February 2001

Evaluation of Confining Layer Integrity Beneath the South District Wastewater Treatment Plant, Miami-Dade Water and Sewer Department, Dade County, Florida

**Idaho National Engineering and Environmental Laboratory
Geosciences Research Department
Idaho Falls, Idaho 83415**

The United States Environmental Protection Agency – Region 4 requested that the Idaho National Engineering and Environmental Laboratory (INEEL) review available information that describe the geology, hydrogeology, and geochemistry at the SDWTP, and to assess whether these data are sufficient for evaluating the integrity of the MCU.

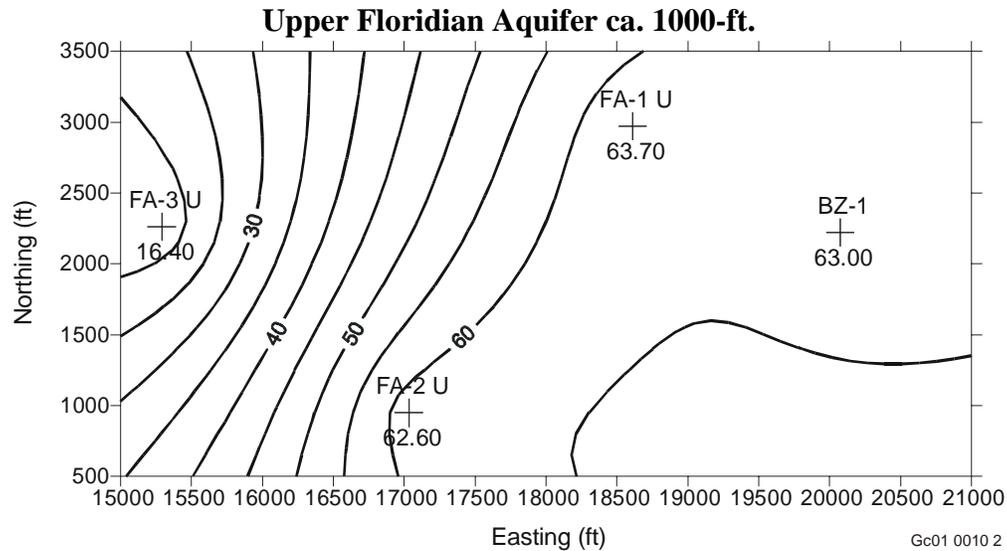
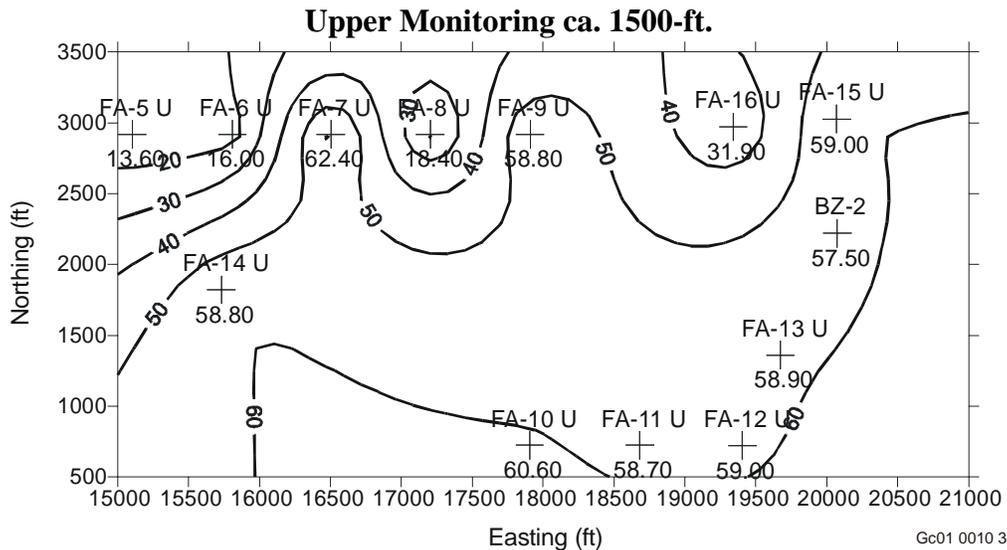
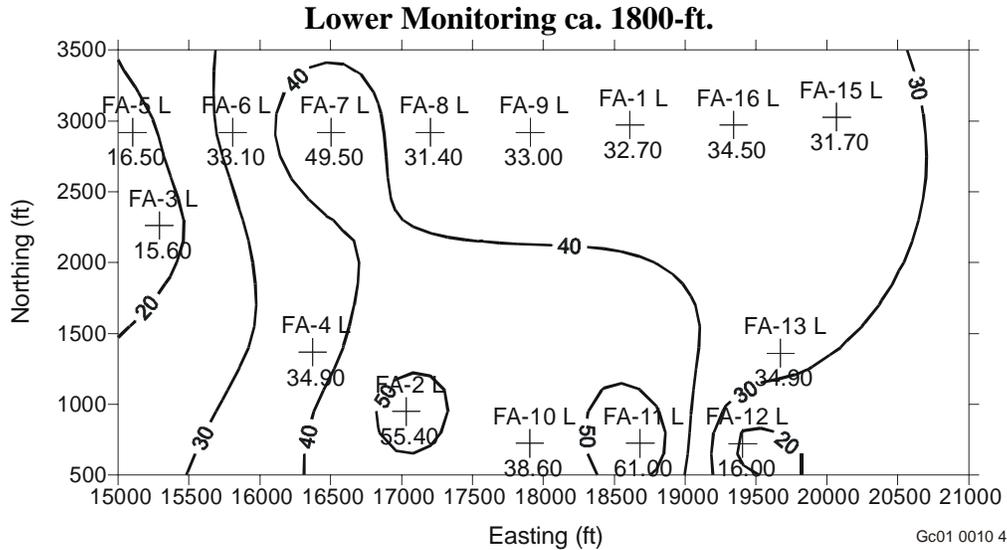
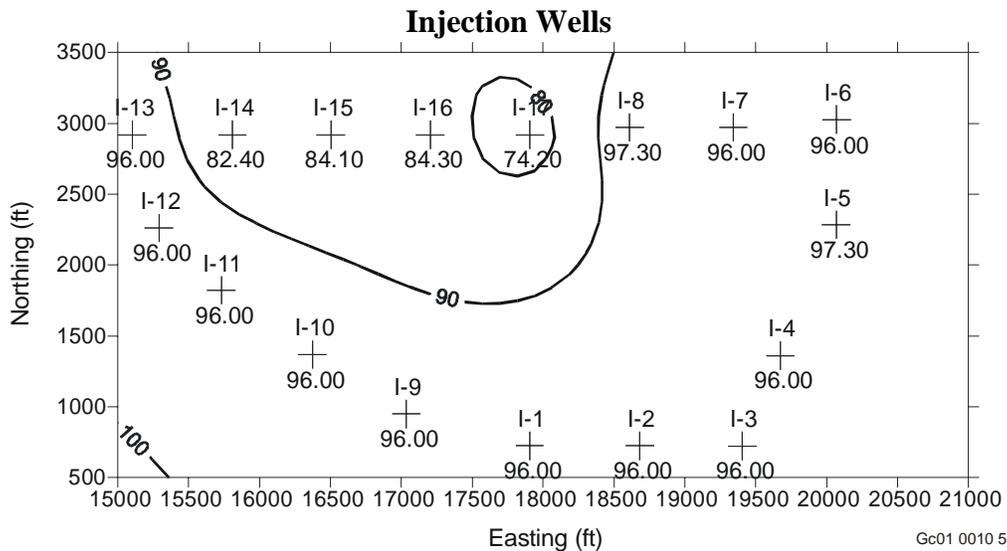
The hydraulic head data sets provided are difficult to interpret because some wells in each interval were probably being purged during the data collection period and because purging of some wells either began or stopped during the data collection period. A better approach for providing data that could be used for determining the lateral and vertical distribution of hydraulic head beneath the site would be to shut in all monitoring wells and to monitor head until recovery to static conditions had occurred. This approach would remove the perturbations to the system caused by drawdown cones created by well purging. If head were monitored until steady-state conditions were reached, then anomalous values could be identified and possibly correlated with hydraulic connections to other hydrostratigraphic units.

Regardless of the effects of the local head perturbations, the hydraulic head in the zone of injection (Figure 5) is higher than that in the Upper Floridan Aquifer (Figures 2 through 4), and therefore groundwater tends to flow upward from the zone of injection, through the Middle Confining Unit, and into the overlying Upper Floridan Aquifer. The amount of water that moves upward through the Middle Confining Unit and the rate at which it moves depends on the hydraulic conductivity of the Middle Confining Unit, which is discussed in the following section.

- The hydraulic head data available for review are inadequate to provide a useful understanding of the head relationships beneath the SDWTP because of the large spatial and temporal changes in head, presumably caused by purging of monitoring wells. The utility of this data set is further compromised because it is not known if corrections for variations in fluid density between wells have been made.

Figure 7. Typical range of hydraulic properties of geologic materials (Freeze and Cherry 1979) and range of observed values at the SDWTP

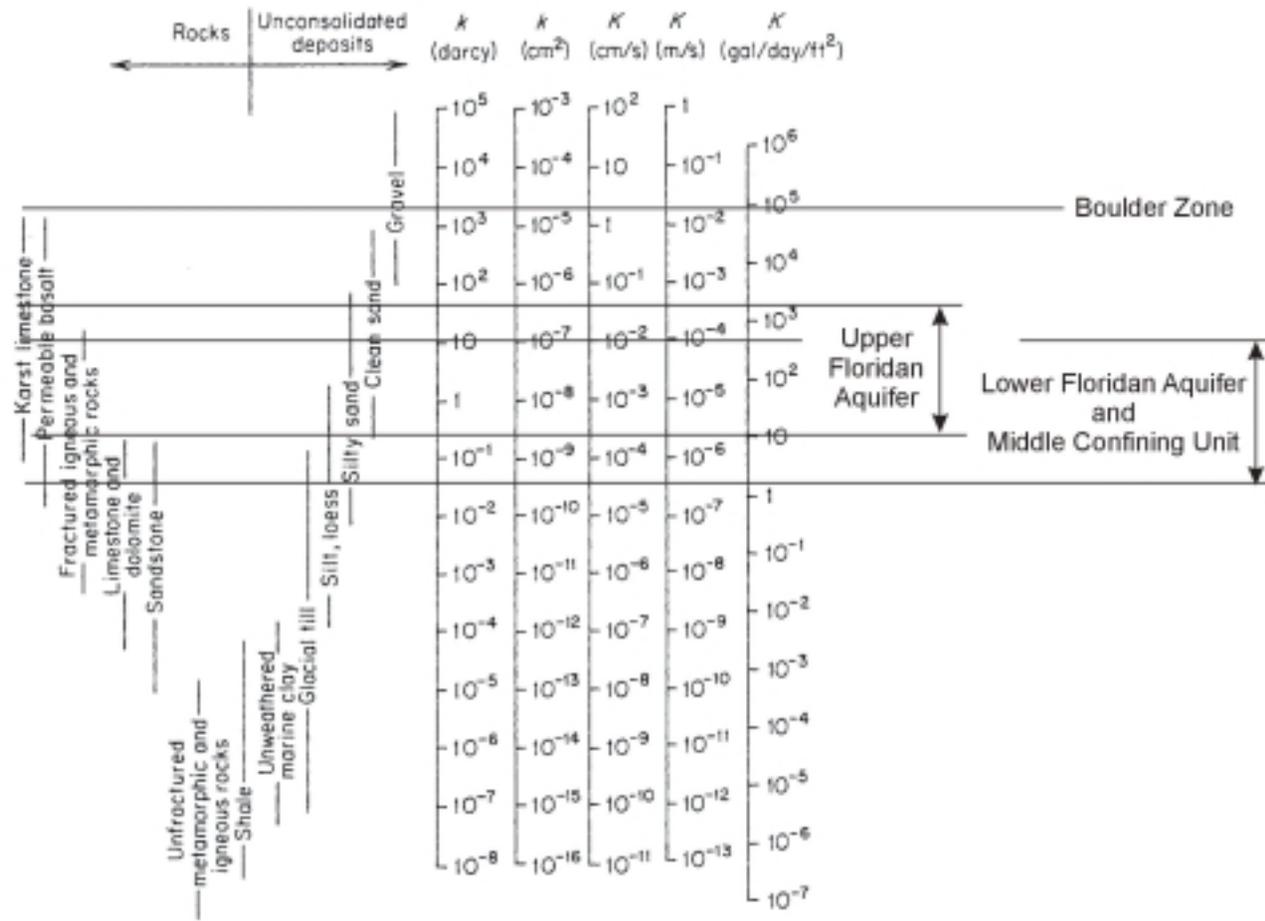
The typical range of permeability and hydraulic conductivity values observed for various consolidated and unconsolidated materials and values observed at the SDWTP are illustrated in Figure 7. This figure provides a basis for comparing the range of values measured at the site to typical values for limestone and other materials.

Three of the five hydraulic conductivity values measured in the Upper Floridan Aquifer are in the range of 1×10^{-4} to $1 \times 10^{-2} \text{ cm s}^{-1}$, and the remaining two values are in the range 1×10^{-2} to $1 \times 10^{-1} \text{ cm s}^{-1}$. The three lower values are in the range measured for the Middle Confining Unit and correspond to the range reported for silty to clean sand and karst limestone (Figure 7). The two higher values fall in the range reported for karst limestone and clean sand.

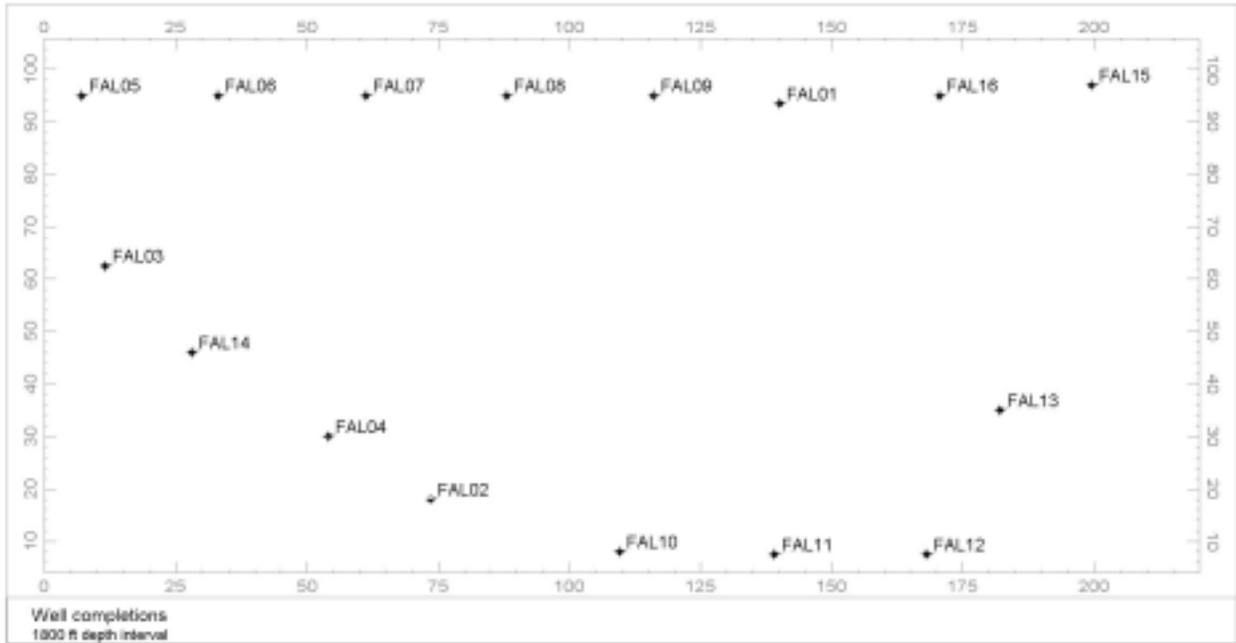
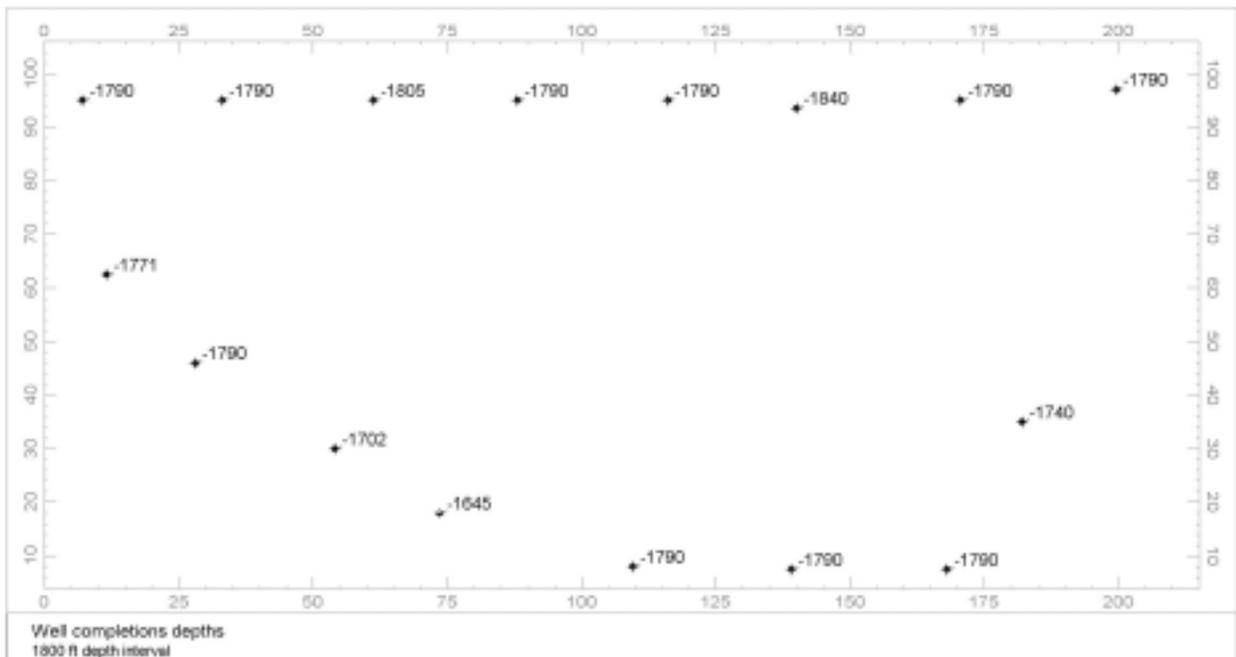
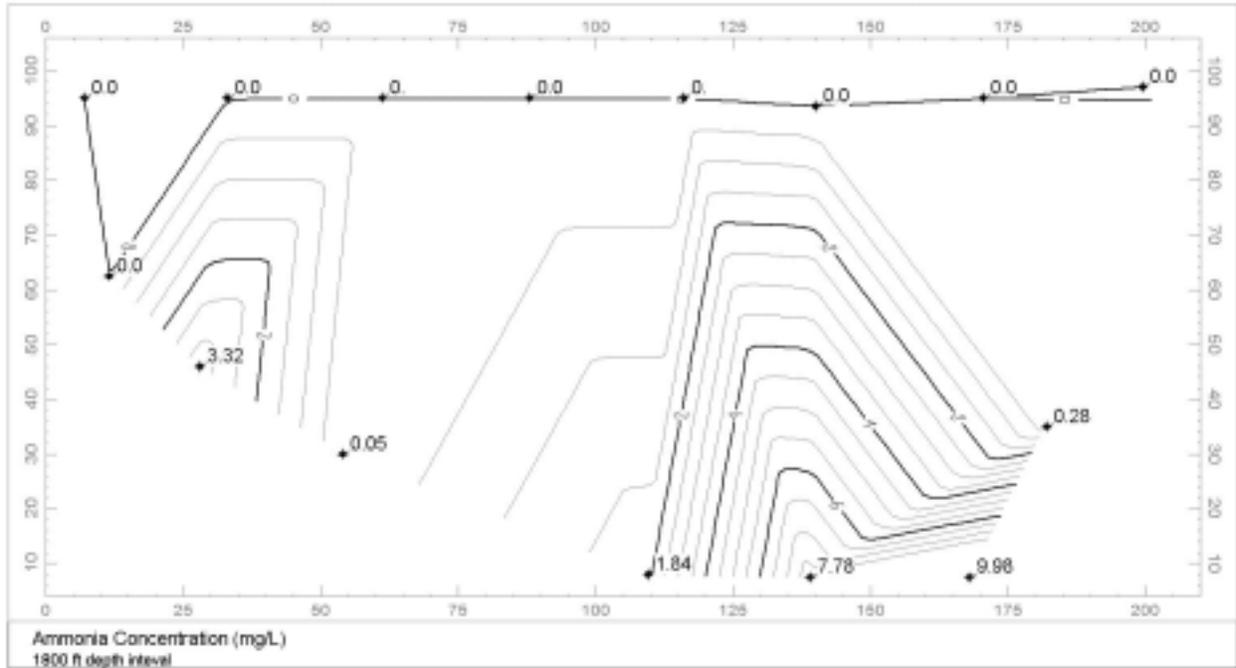
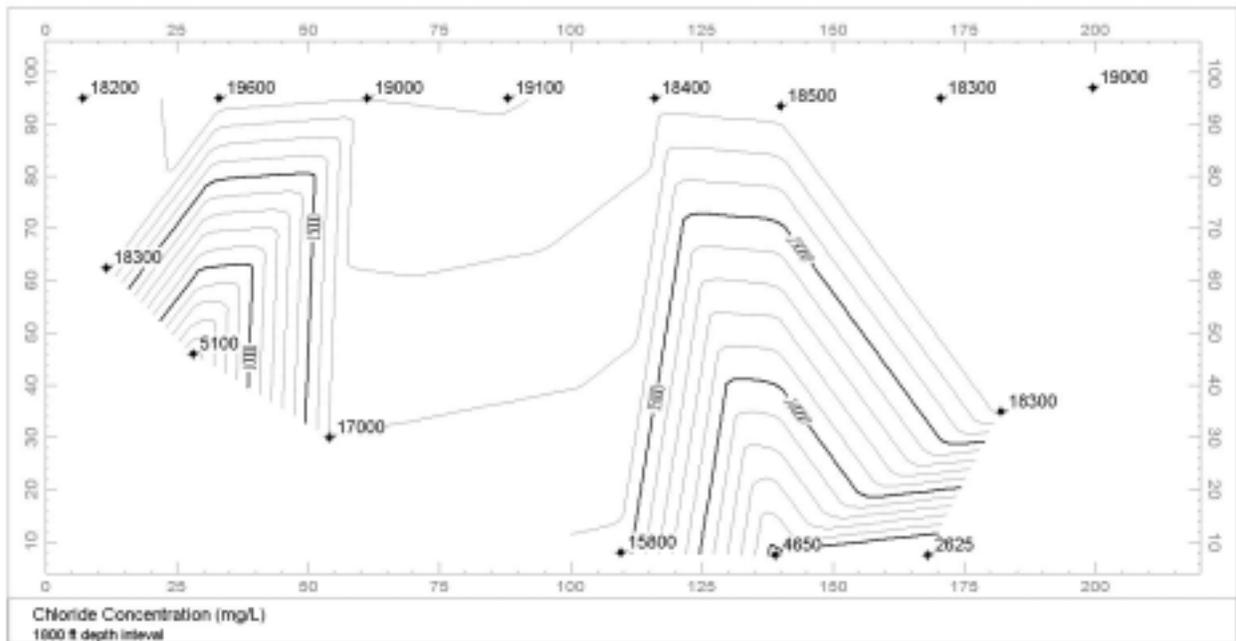
At the 1,800-ft depth interval, three or four wells show a distinctly lower chloride concentration than the other wells completed at the same depth. Wells FAL11, FAL12, and FAL14 are significantly lower in chloride than the remaining wells. Well FAL10 is slightly lower in chloride than the main grouping of wells. At the 1,500-ft depth interval, the wells show a small range of chloride concentrations, but not the distinct difference seen at 1,800-ft.

The spatial distribution in species at a depth interval may provide information on whether migration is localized or spread over a broad area. A map of wells completed at the 1,800-ft depth interval is provided in Figure 11, and the completion depths of the wells are shown in Figure 12. A map of the ammonia concentration at the 1,800-ft depth zone is provided in Figure 13. A map of the chloride concentration at the 1,800-ft depth zone is provided in Figure 14. Comparison of Figures 13 and 14 shows a high inverse correlation between chloride and ammonia. Wells with elevated ammonia levels are the same wells that have a decreased chloride concentration. From the spatial distribution of the concentrations, it appears that the contamination is related to point sources, rather than a widely distributed source. The conclusion from this distribution of ammonia and chloride in the 1,800-ft zone is that the contamination in this zone is not the result of widespread upward migration through the confining layer, but migration from point sources at or close to two or three wells. There are point sources at or near wells FAL14 and FAL 12. Contamination at Wells FAL10 and FAL11 could be originating near FAL12, or there also may be a lesser amount leakage at or near these wells.
